STAFF REPORT

RZ 2014-PR-025 and SE 2014-PR-001

RESIDENCE INN AT TYSONS

SPECIAL EXCEPTION PLAT / GENERALIZED DEVELOPMENT PLAN

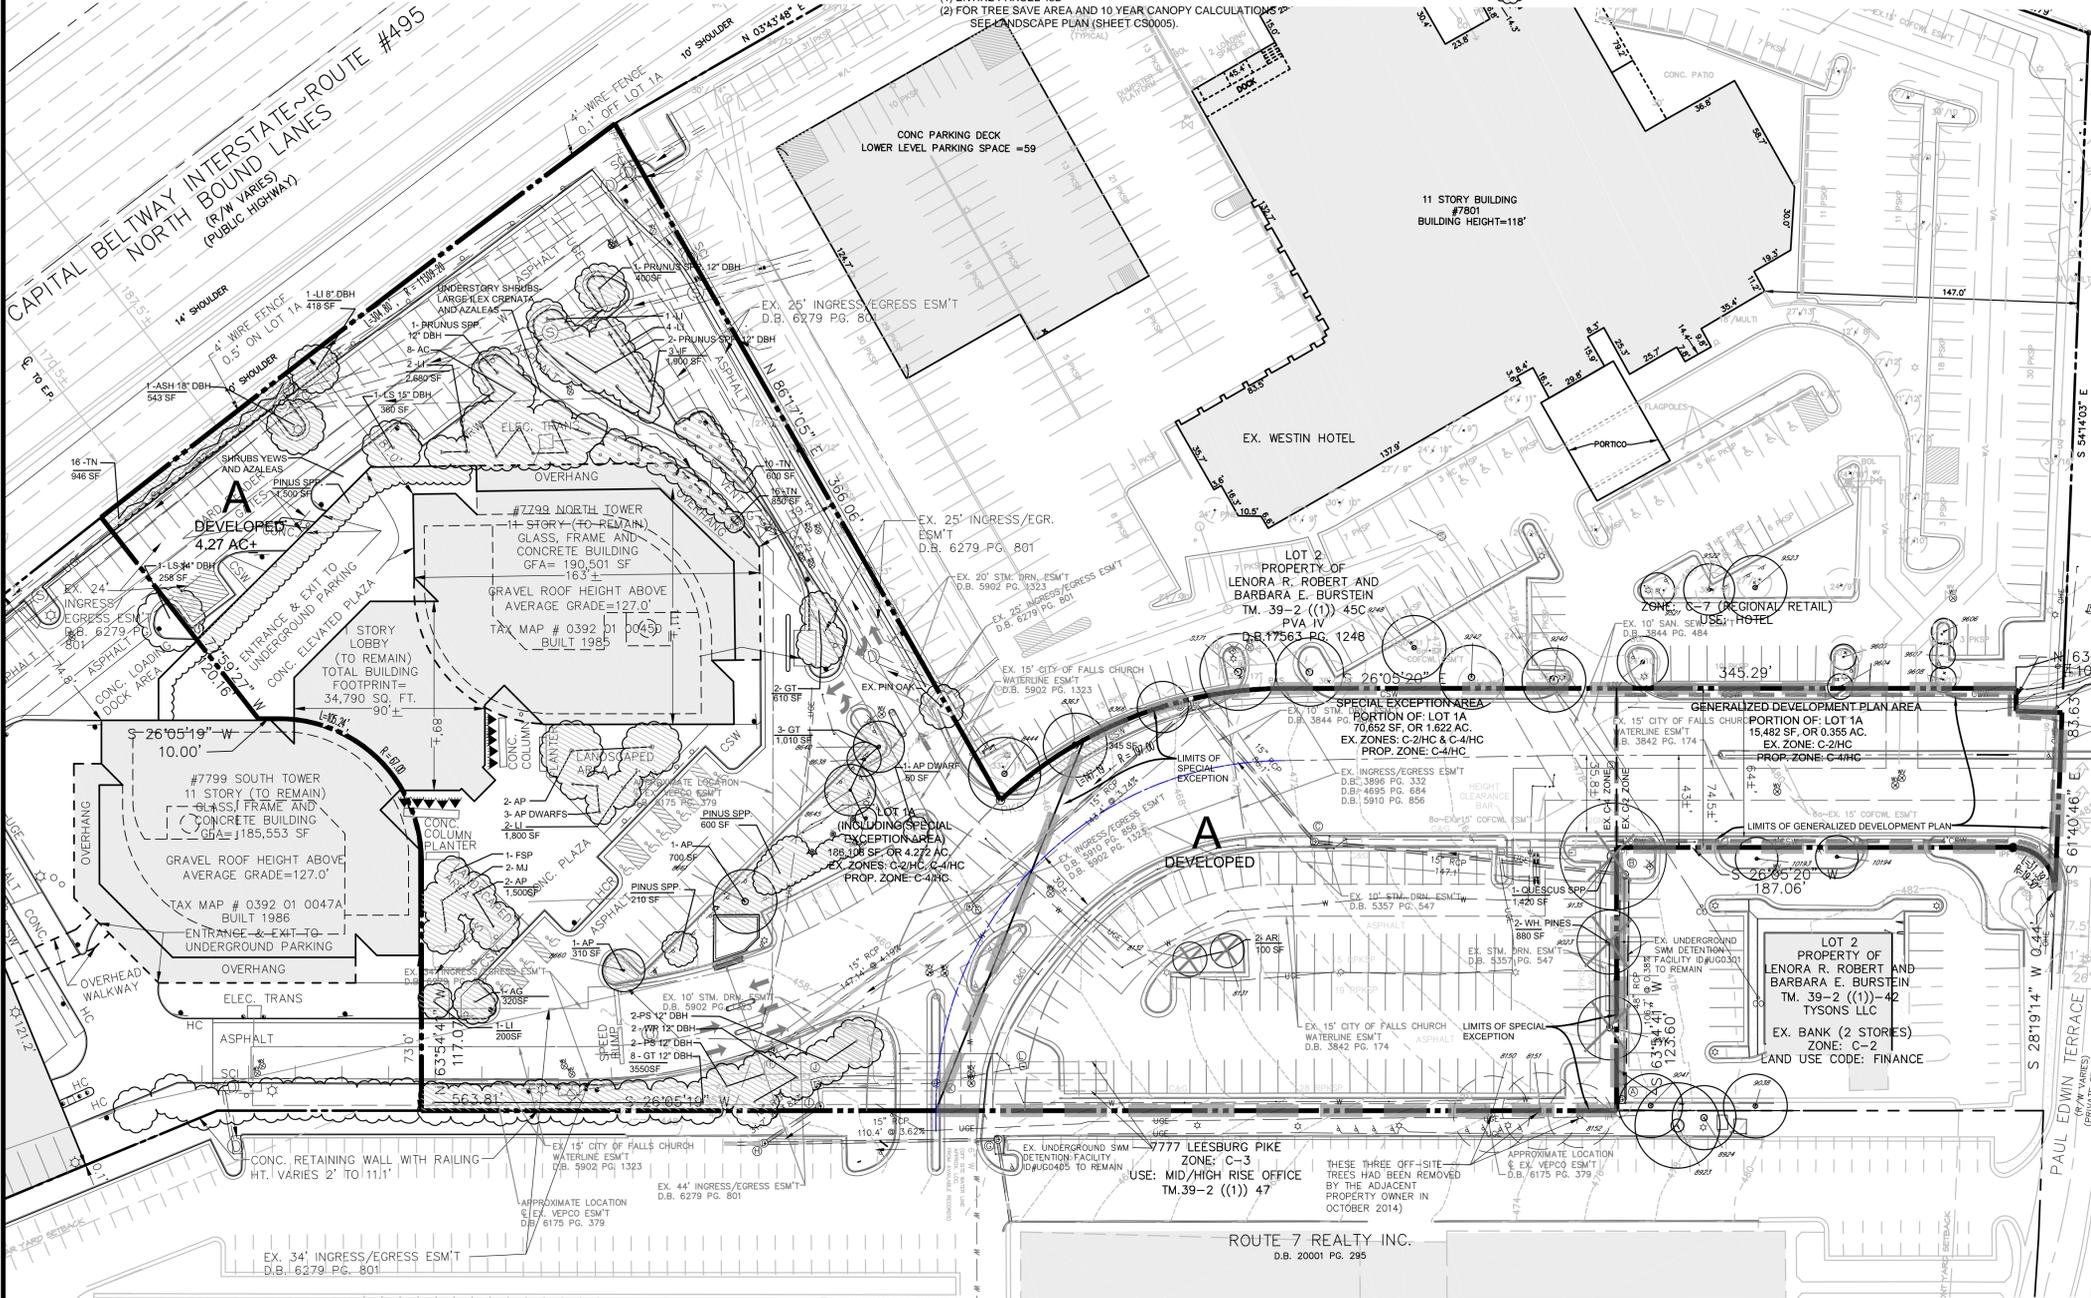
- 1) Sheet 3. Clearly show location of the existing stormwater management facilities (County ID UG0301 & UG0405), and provide appropriate labels.
- 2) Sheet 4. Show and label the existing stormwater management facility on the bank property.

PROJECT NO. LERN1201	16 OF 19
SCALE AS SHOWN	DATE 2013-08-15
DRAWN BY MBR	APPROVED DHS
DRAWING NO. SE2014-PR-001	CS0016

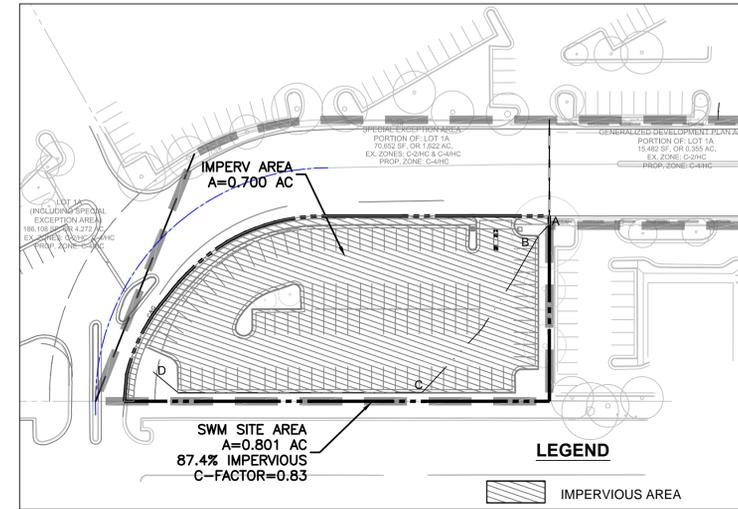
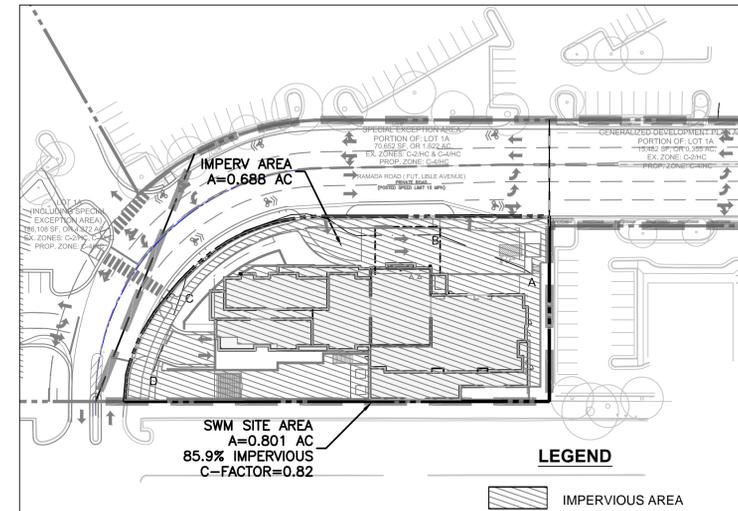
Water quality controls are required for this redevelopment. The applicant indicates that the phosphorous removal requirements will be satisfied with the use of green roof and urban bio-retention areas. Preliminary computations have been provided on Sheet 16E.

- 6) Sheet 16E
 - a) The rooftop planters do not meet current PFM standards. No phosphorous credit can be taken.
 - b) Removal efficiency for green roof is 40% per PFM.

DRAINAGE DIVIDE MAP

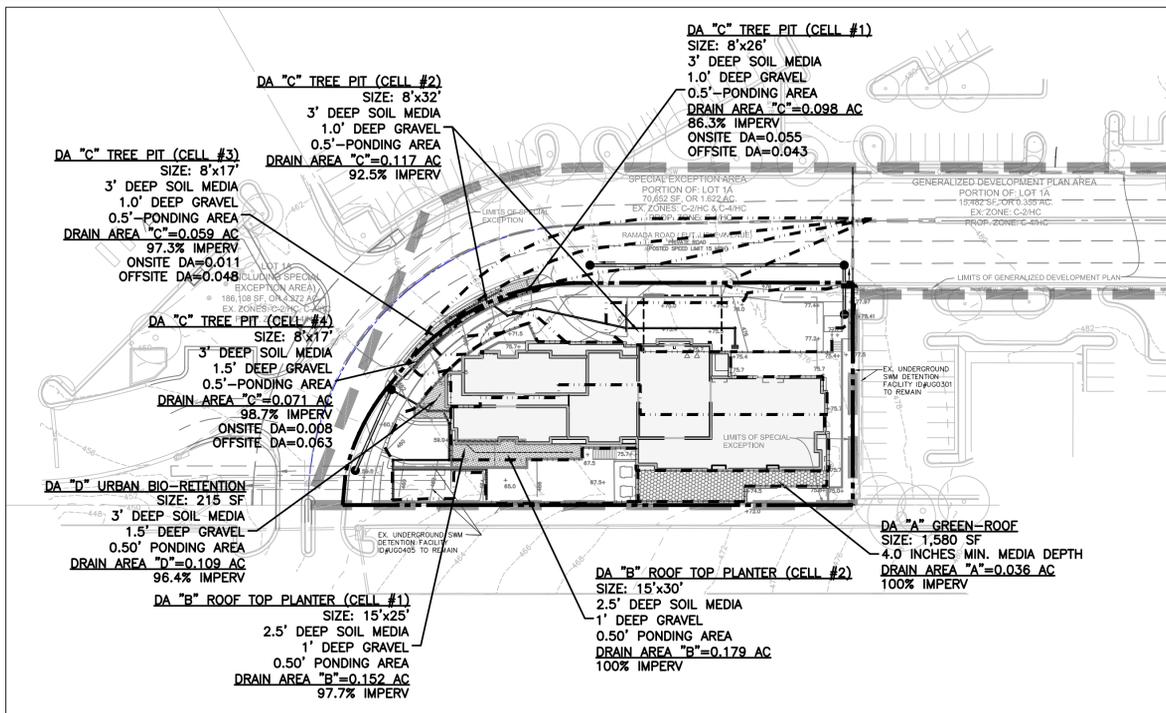
The applicant has provided a preliminary computation on Sheet 16A stating that 100% of the applicable site area is captured by a BMP, and 1.00 inch of rainfall will be retained on-site through the use of runoff reduction methods including vegetated roof, rooftop planters, and bio-retention. This includes offsite area along Ramada Road being treated with onsite facilities.

- 3) Sheet 16A.
 - a) Please consolidate all onsite areas into "Drainage Area A". The total area of "0.80" shall be used. The intent of having five drainage areas is to allow users to have separate drainage areas based on the outfalls of the site. However, the information presented has separated the drainage areas based on the facilities.
 - b) The credit achieved by treating offsite areas can be added through a separate calculation, like the one on the left side of this sheet. There is no need to show the Land Use Summary for Offsite drainage area.
